URGENT - Field Safety Notice Juno DRF

Additional safety label for table base

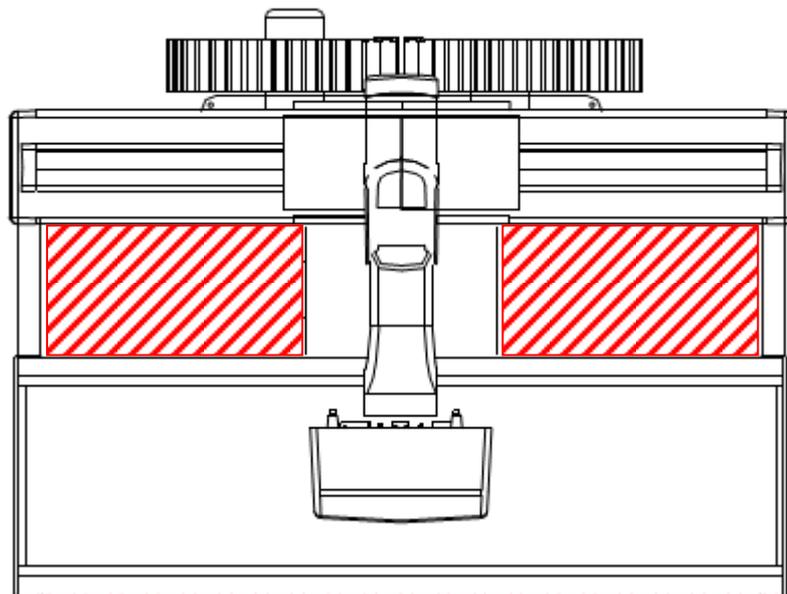
In the areas highlighted in the following picture the **risk of squeezing** is present between the detector carrier structure and the tabletop supporting arms in case the motorized movements are activated.

It is forbidden to enter or stay in such areas when the system is powered on.

ACTIONS PLANNED BY PHILIPS	<p>Philips will provide improved directions for use (including device labeling) that include:</p> <ul style="list-style-type: none">• An additional warning sign ISO 7010:2011 W019  <ul style="list-style-type: none">• A prohibition sign banning access to the prohibited area• Additional Safety information to be attached the the IfU precisely explaining<ul style="list-style-type: none">○ the prohibited area○ the hazard○ countermeasures in case of a violation of the prohibition○ the additional device labeling.. <p>You will be contacted by Philips to schedule the installation.</p> <p>Should you need to communicate with Philips with regard to this program, please reference FCO-70900032.</p>
FURTHER INFORMATION AND SUPPORT	<p>If you need any further information or support concerning this issue, please contact your local Philips representative.</p>
